APPLICATION FOR AMENDMENT  
TO OPERATING LICENSES

Technical Specification  
Page Revisions

Consolidated Edison Company of New York, Inc.  
Indian Point Unit No. 1  
Docket No. 50-3  
March, 1981

Consolidated Edison Company of New York, Inc.  
Indian Point Unit No. 2  
Docket No. 50-247  
March, 1981

Figure 3.1 Facility Management and Technical Support Organization

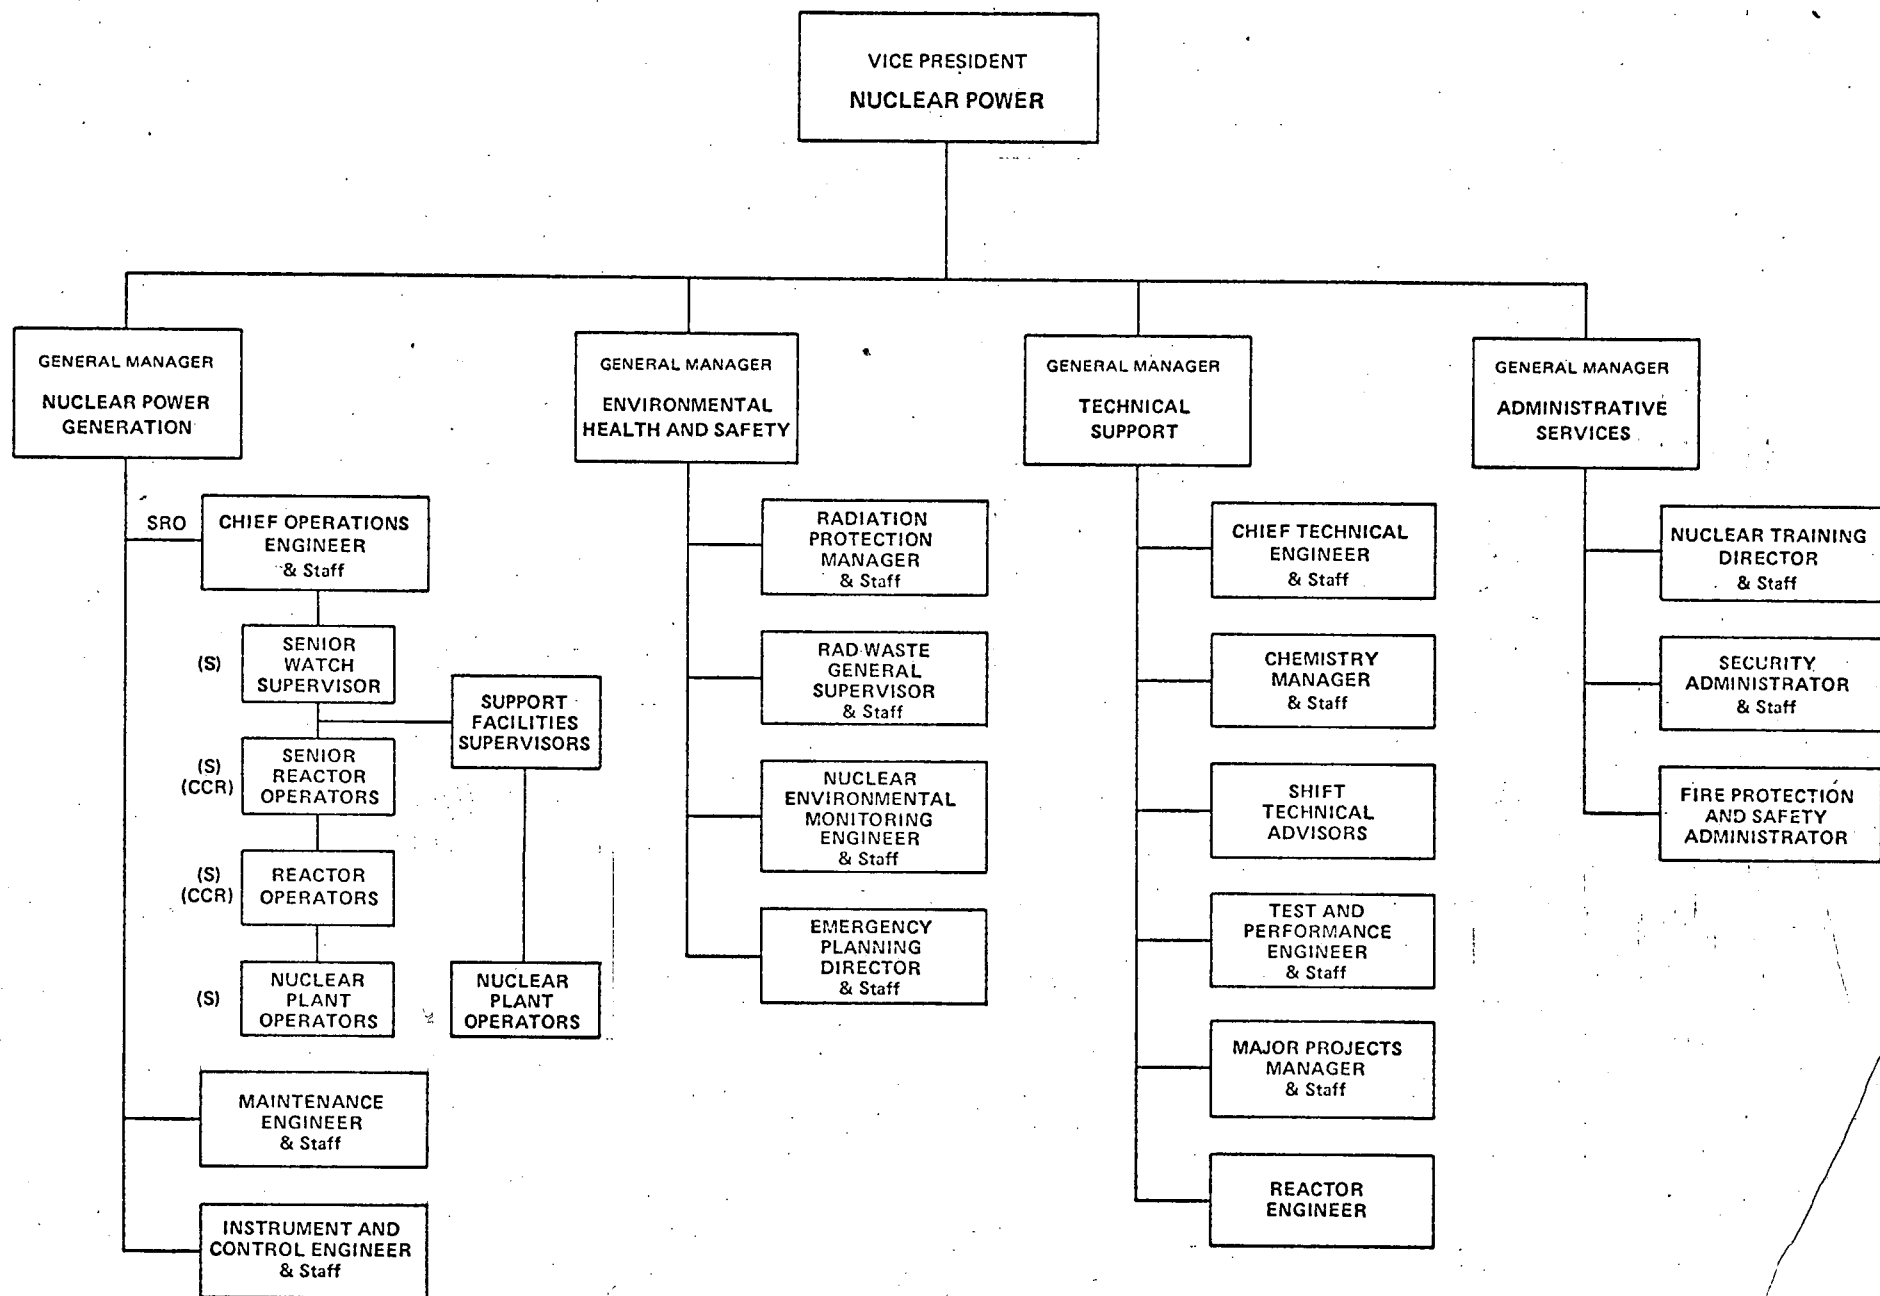
3.1.1 The organization for facility management and technical support shall be as shown in Figure 3.1.

The proposed technical specification revisions, contained in Attachments A and B to this Application, would effect certain organizational and administrative changes relative to facility management and technical support and to the facility organization. The proposed changes to section 3.1 of the Indian Point Unit No. 1 Technical Specifications (Attachment A) and to Sections 6.1, 6.2, 6.3, 6.5, 6.6, 6.7 and 6.8 of the Indian Point Unit No. 2 Technical Specifications (Attachment B) would require that: (a) the Vice President-Nuclear Power be responsible for overall facility safety and the General Manager-Nuclear Power Generation be responsible for facility operations, (b) the Station Nuclear Safety Committee (SNSC) be chaired by the General Manager-Technical Support and that SNSC report to and advise the Vice President-Nuclear Power, and (c) the facility be managed and operated in accordance with the pending organizational changes reflected on revised Figures 6.2-1 and 6.2-2 and in specification 6.5.1.2. In addition, requirements for the Shift Technical Advisor (STA) have been proposed for Sections 6.2 and 6.3 of the Unit No. 2 Technical Specifications.

Figure 6.2-1 Facility Management and Technical Support Organization

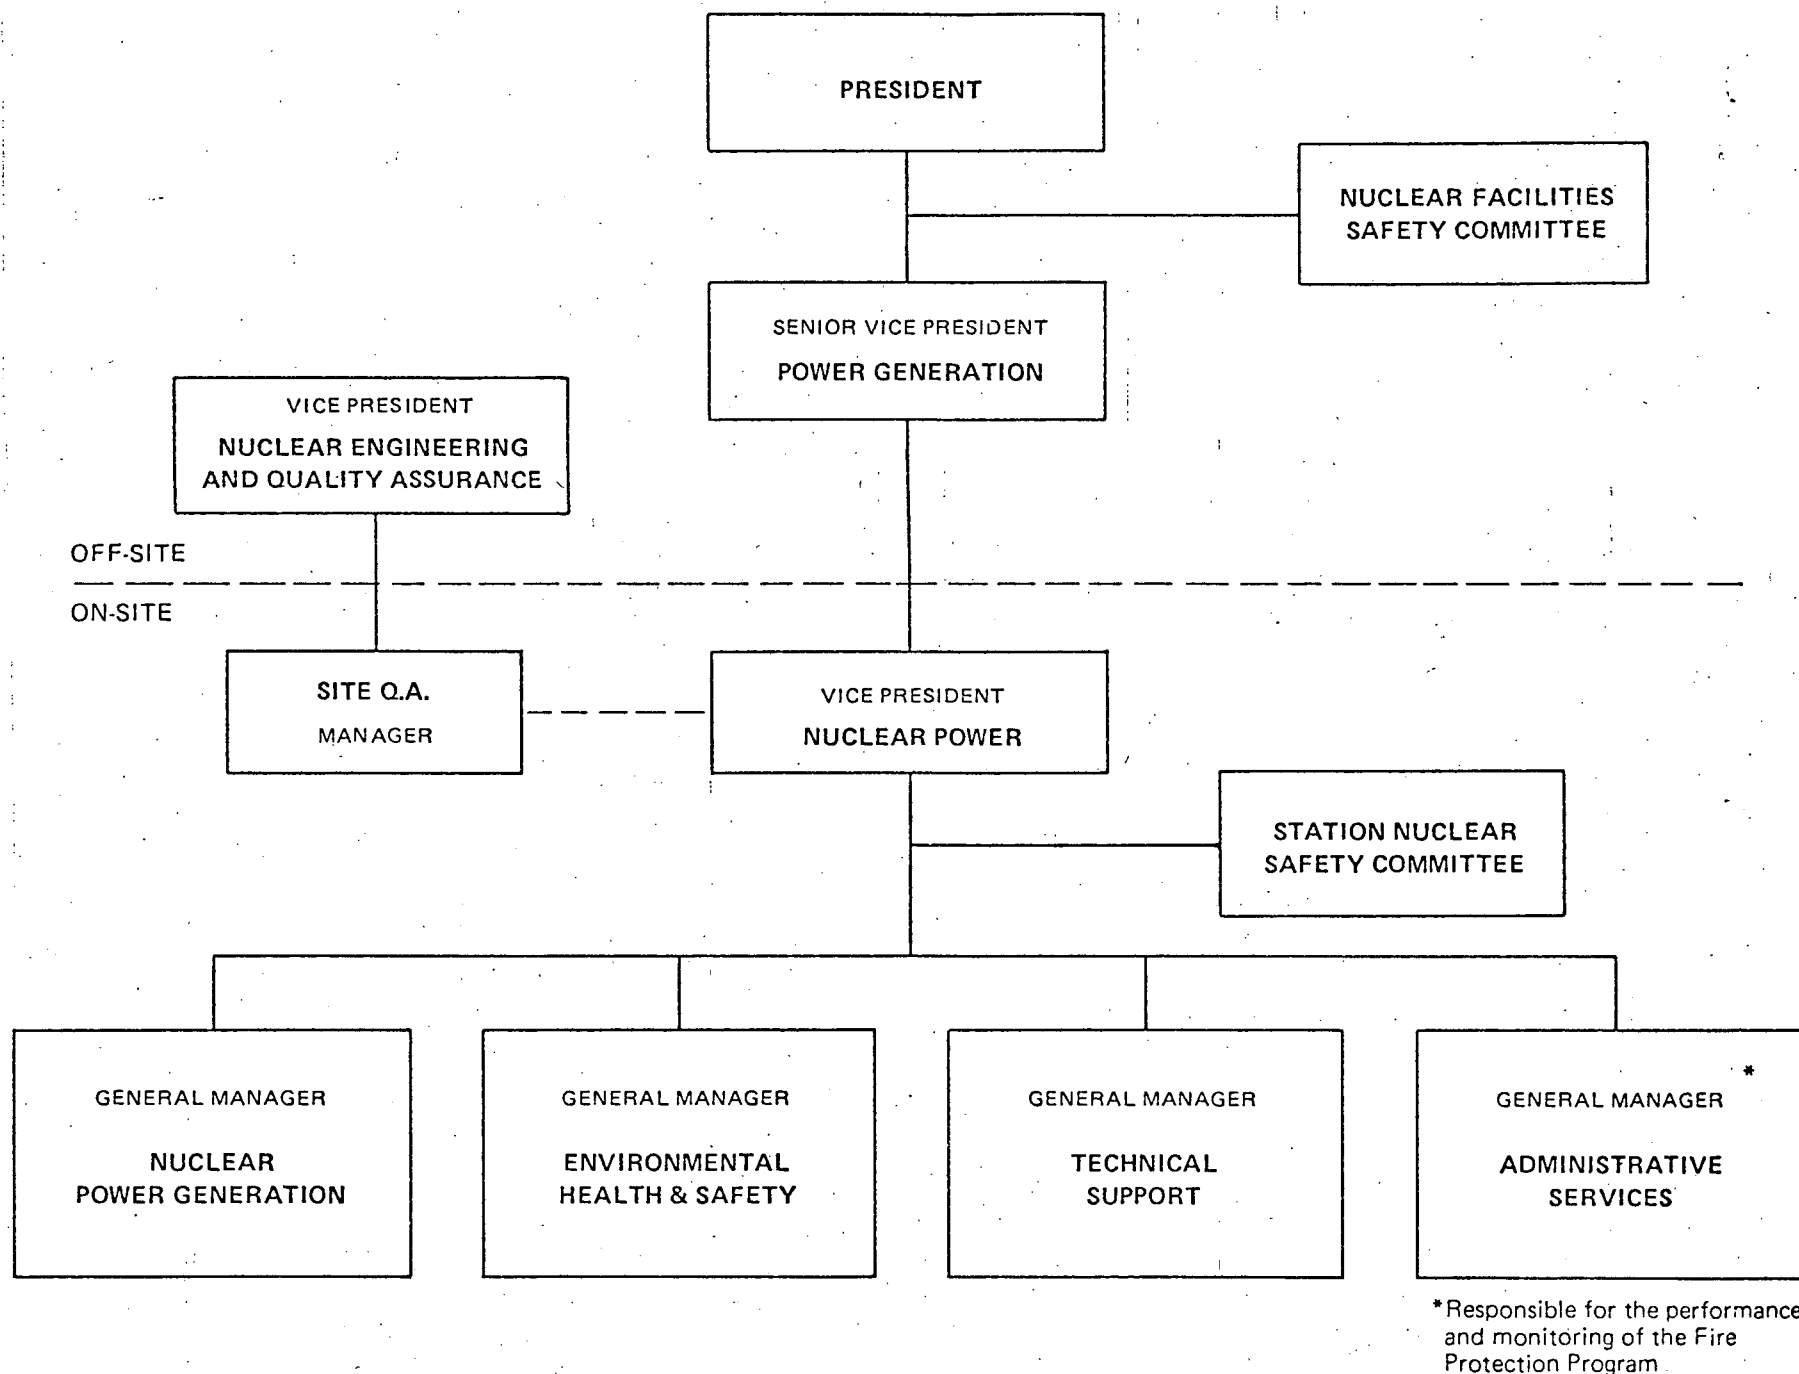
6.2.1 The organization for facility management and technical support shall be as shown on Figure 6.2-1.

Figure 6.2-2 Facility Organization

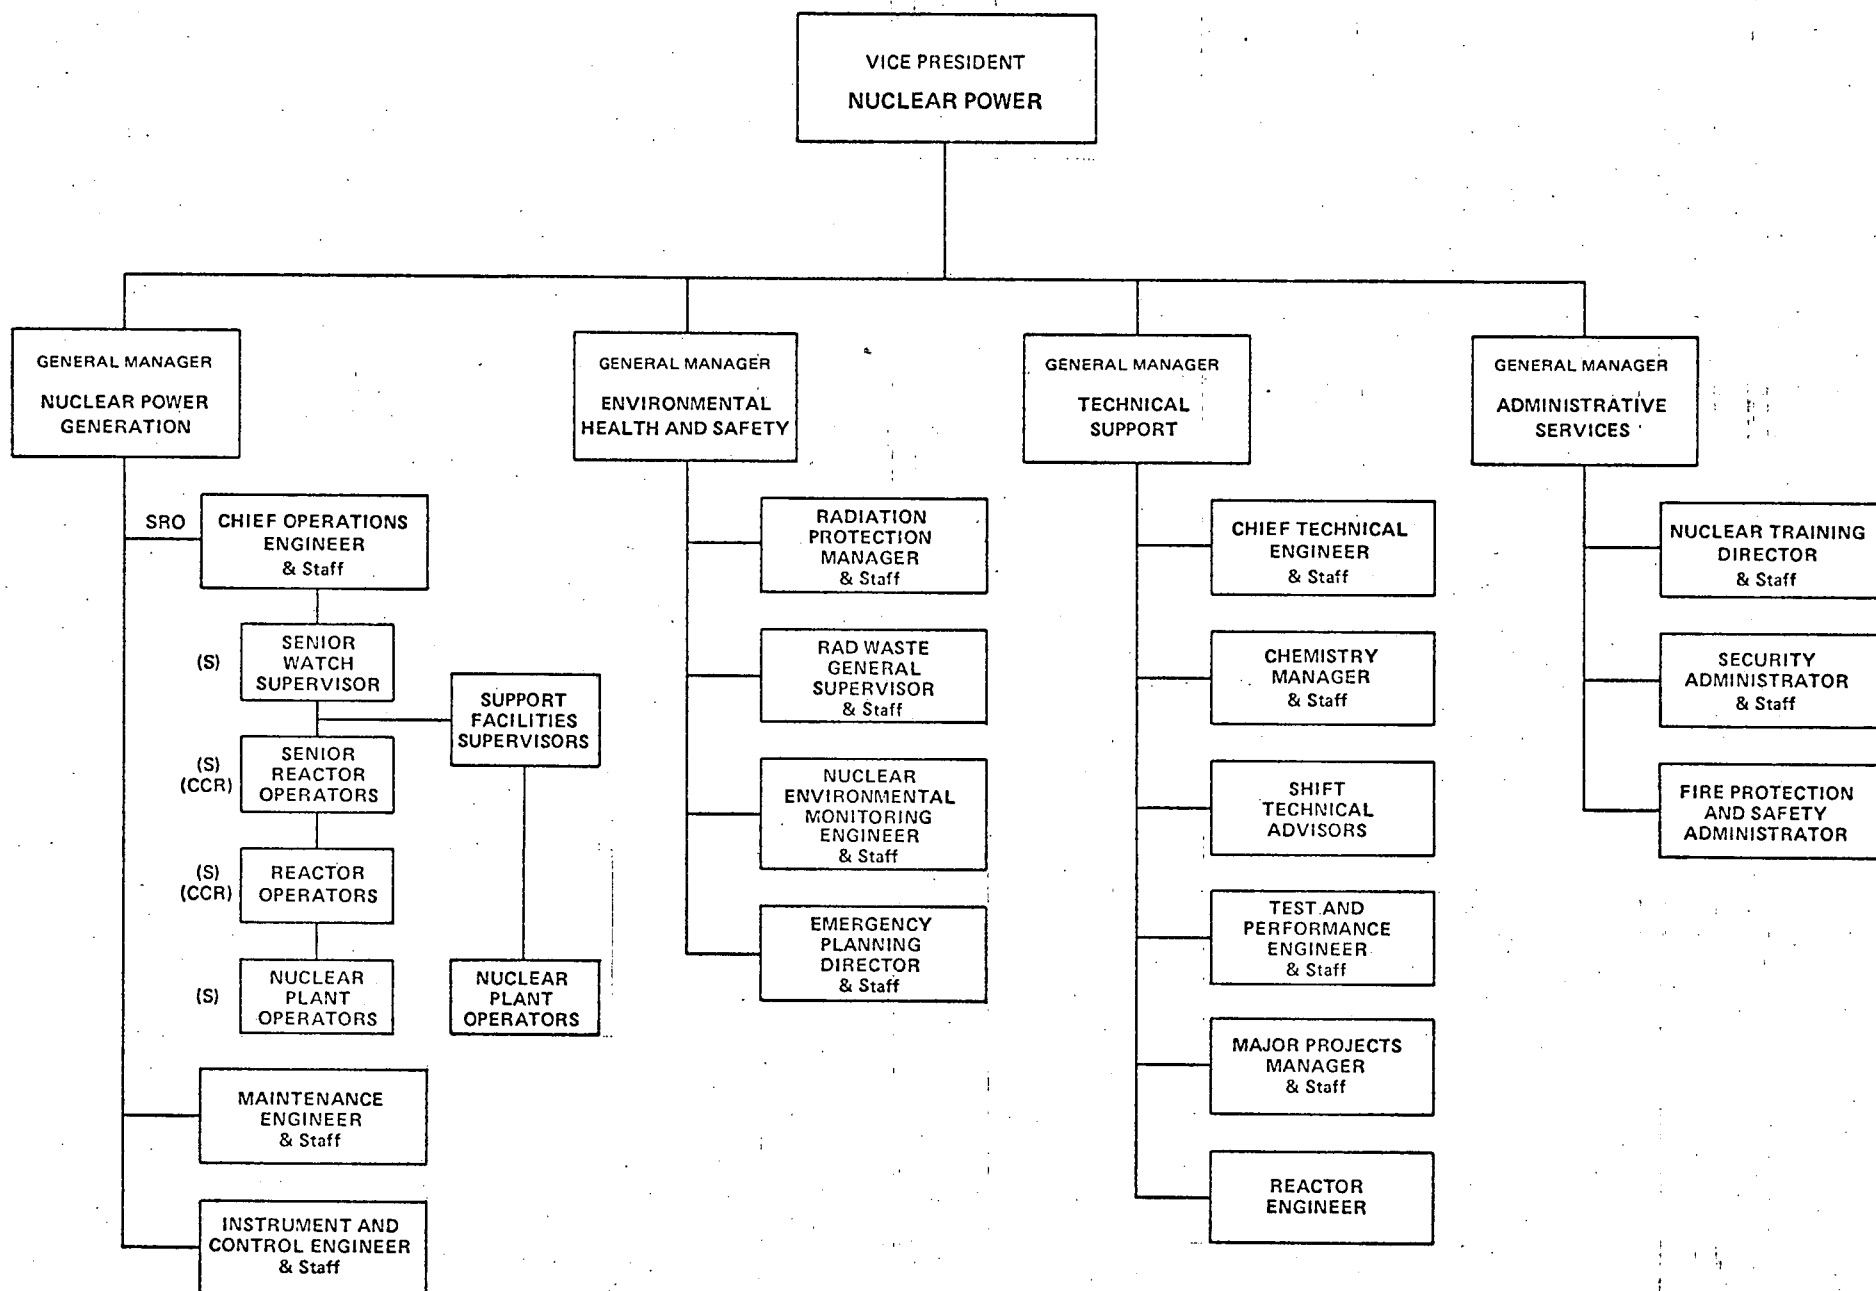
6.2.2 The Facility organization shall be as shown on Figure 6.2-2 and:
